## Product Change Notification / ALAN-03HTZP673

CCB 4993 Final Notice: Qualification of 3280 die attach material and new lead frame design for selected products available in 8L SOIC package assembled at MMT assembly site.

**CCB 4993**  
**Pre and Post Change Summary**  
**PCN# ALAN-03HTZP673**

## Pre Change

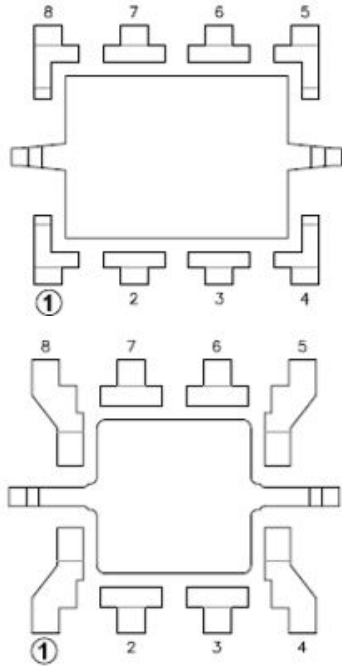
Lead-lock

No

## Post Change

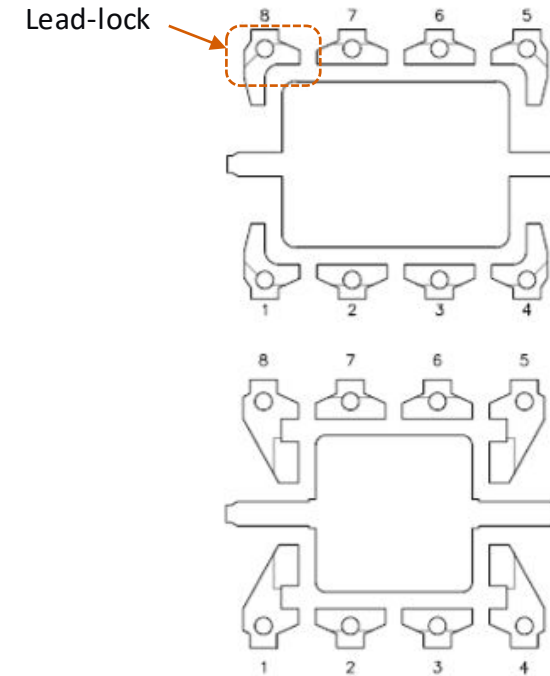
Lead-lock

Yes

Note: Mold compound materials fills the leadlockhole, which provides improved protection against moisture penetration along the edge of the leads (pins) of the package.
